Date: 3 June 2010

Subj: Modeling for Cape Wind's Local Impacts Relative to the National Ambient Air Quality Standards

From: Brian Hennessey, Region 1 Air Modeling Contact
Air Permits Program, OEP

To: Ida McDonnell, Manager
Air Permit Program, OEP

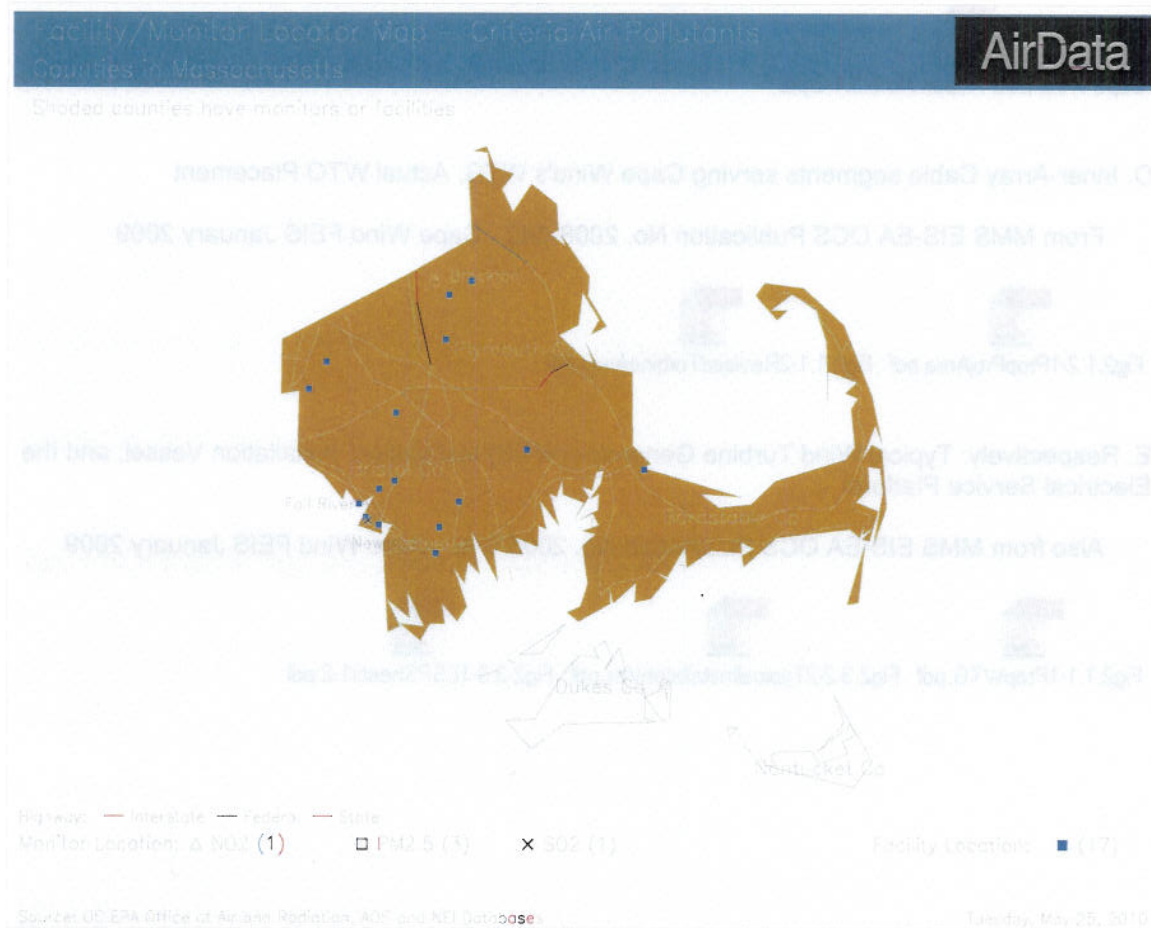
The PM_{2.5} 24-hour standard will be most closely approached but it should be noted that the background data not the construction emissions dominates the outcome of the PM_{2.5} modeling. To investigate EPA's AirData were retrieved from the monitoring sites (See the map below) nearest Cape Wind for the years 2003- 2008 as a check on the background values used in the Final EIS's modeling analysis. For the years 2003 thru 2005 the observation-weighted average of 98 %-tile highest 24-hour PM_{2.5} at the Commercial Street urban/center city monitors in Brockton is 30.29 ug/m³ within the NAAQS but considerably higher than what ESS's analysis used. More recently this monitor recorded lower values of the 98 %-tile highest PM_{2.5} but in these years, too, the Brockton data cannot be considered representative of Cape or especially the location where construction would have the greatest impact on PM_{2.5} air quality. Even the Globe Street (Fall River) PM_{2.5} data which ESS appears to have used will suggest the Cape has worse air quality than it does.
